SUNDRY NOTICES AND REPORTS ON WELLS
**Do not use this form for proposals to drill or to re-enter an
abandoned well. Use Form 3160-3 (APD) for such proposals.**

8. Well Name and No.
H B 11 Federal 11

Proposed Plug & Abandonment

H B 11 Federal 11
30-015-29739
Devon Energy Production Company, LP
July 25, 2013
Conditions of Approval

PROPOSED PLUG & ABANDONMENT

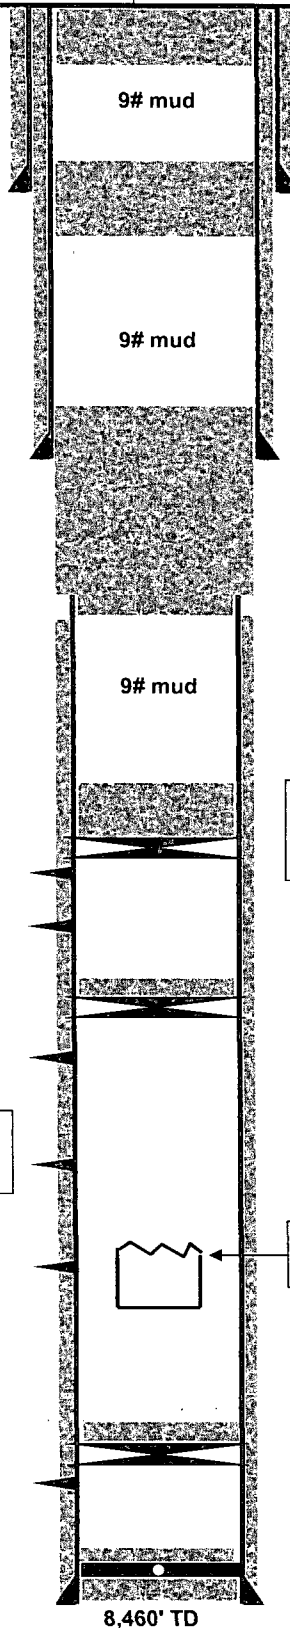
1. Drill out the CIBP at **6,480'**.
2. Set a CIBP at **6,950'** and place a minimum of 25 sxs Class C cement to seal the stuck tbg and the Bone Springs formation.
3. Set a CIBP at **6,456'** and place minimum 25 sxs Class C cement on top. **WOC. Tag required.** *J. Amos 7-26-13*
4. Set a CIBP at **5,260'** and place minimum 25 sxs Class C cement on top. **WOC. Tag required.** *J. Amos 7-26-13*
5. Perf at **3,262'**. Squeeze from **3,262'-2,918'** to seal the Delaware formation, 8-5/8 shoe, and bottom of salt. **WOC. Tag required.**
6. The operator can either:
 - a. Perf at **666'**. Squeeze cement to **300'** to cover top of salt and shoe. **WOC. Tag required.** Perf at **60'** and squeeze cement to surface.
 - Or
 - b. Perf at **666'**. Squeeze cement to surface.
